Inspection Report Minerals Regulatory Program

Mine Name: Desert Sienna	Permit numbe (unpermitted)	er: S/015/09)3
Operator Name: Bown Stone Products	Inspection Da Time: About	•	
Inspector(s): Paul Baker Other Participants: Rebecca Doolittle, Price BLM Mine Status: Unpermitted	Weather: Cle	ear, 30's, a li	ttle snow on
Elements of Inspection	Evaluated	Comment	Enforcemen
 Permits, Revisions, Transfer, Bonds Public Safety (shafts, adits, trash, signs, highwalls) Protection of Drainages / Erosion Control Deleterious Material Roads (maintenance, surfacing, dust control, safety) Concurrent Reclamation Backfilling/Grading (trenches, pits, roads, highwalls, shafts, drill holes) Water Impoundments Soils Revegetation Air Quality Other 			
Purpose of Inspection: We wanted to see where this site is and to see what the conditions are like.

S/015/083, Desert Sienna Mine, Bown Stone Products

Inspection Dated: January 20, 2006; Report Dated: February 8, 2006

ownship 21 S Range 08 E Section 06 SLBM Mine Name: Desert Sienna Mine Number: S0150093

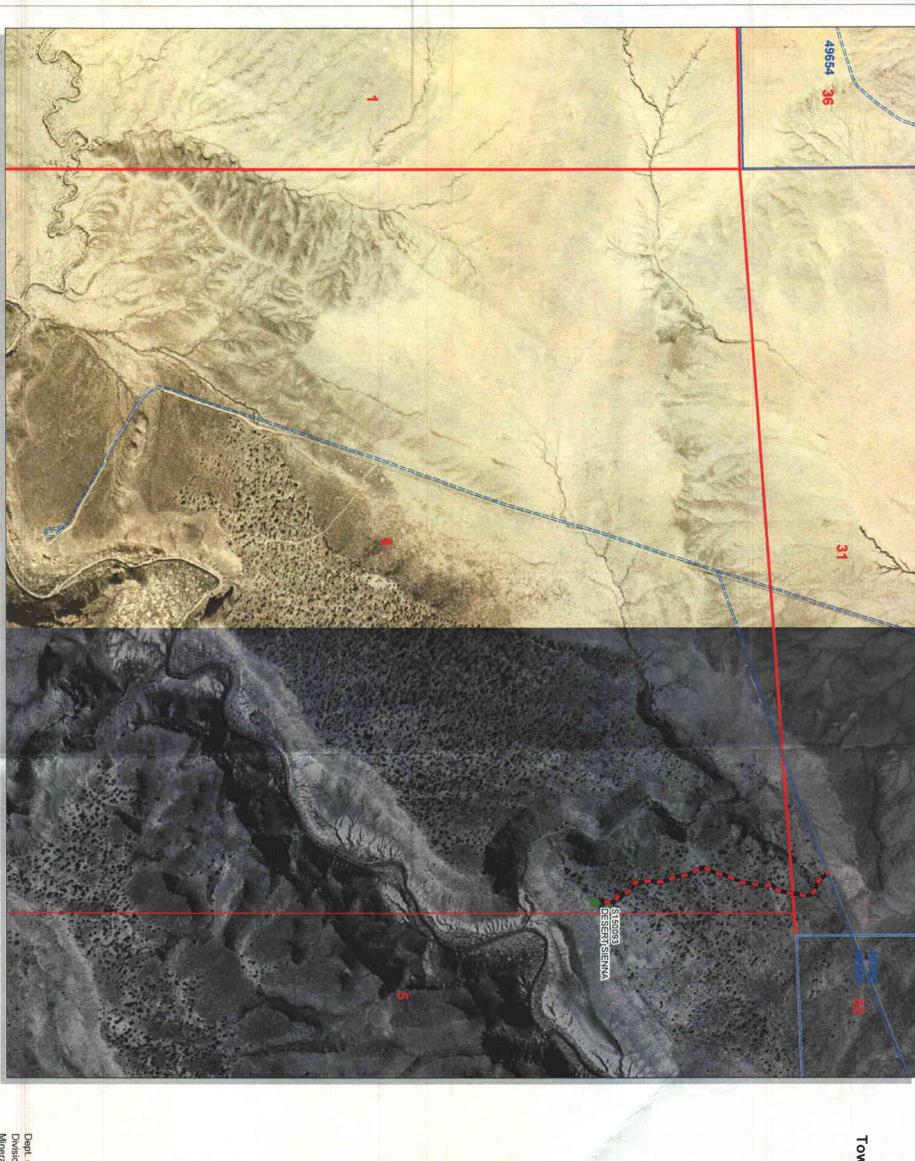
There is an existing road to within a few hundred yards of the edge of the canyon, and there is something of a two-track road that winds through the trees to near the canyon (see the attached map). This two track road will need to be included as part of the disturbed area. The operator intends to

make some modifications to the existing east-west road, and these modifications will also need to be part of the disturbed area.
